MS context release indication

Introduction

Figure xx: Handover procedure involving RS with centralized HO control from MR-BS

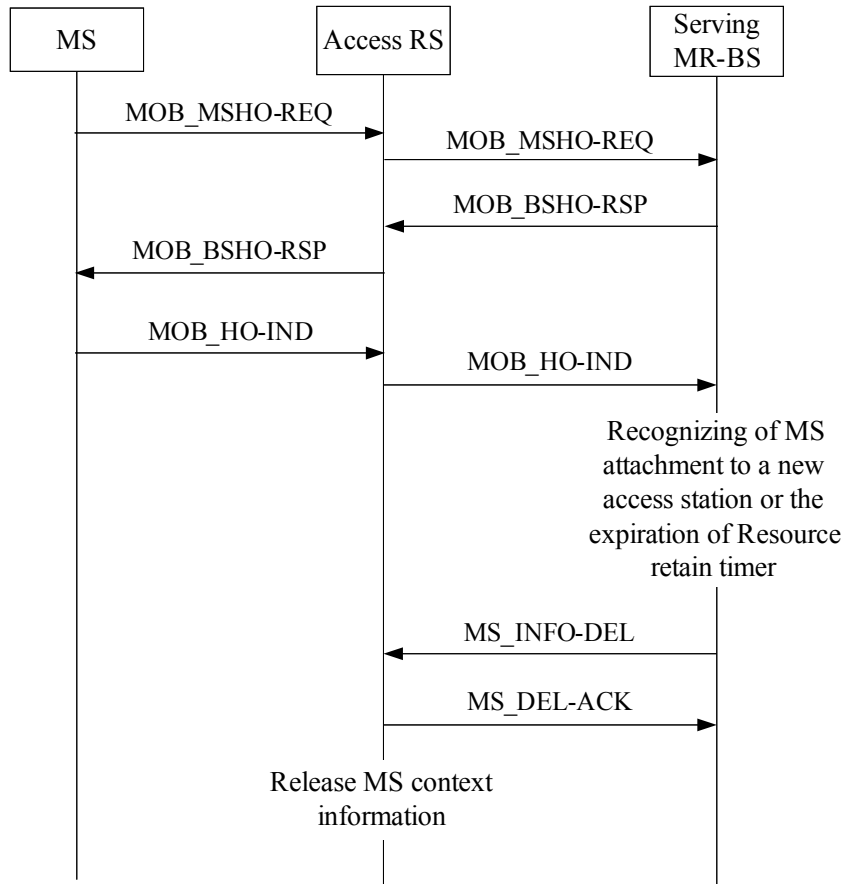
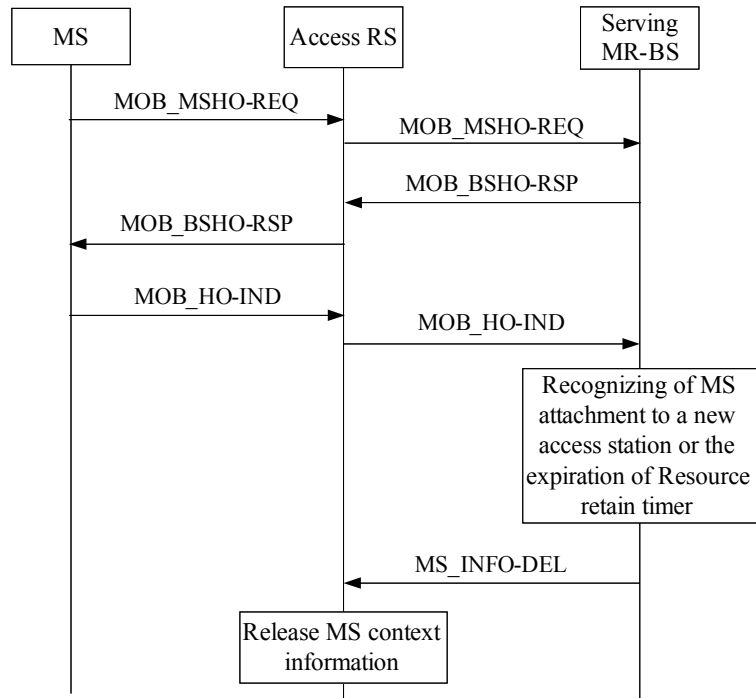
[Insert the followings at the end of section 6.3.22.5.1 in page 30]

If a serving MR-BS recognizes that MS attaches to a new access station or Resource retain timer expires, and the MS's old access station is an RS which is controlled by the MR-BS, the MR-BS may send the MS_INFO-DEL message to make the RS discard MS context information. Upon receiving the MS_INFO-DEL message, the RS shall transmit MS_DEL-ACK as a reply and remove the MS context information.
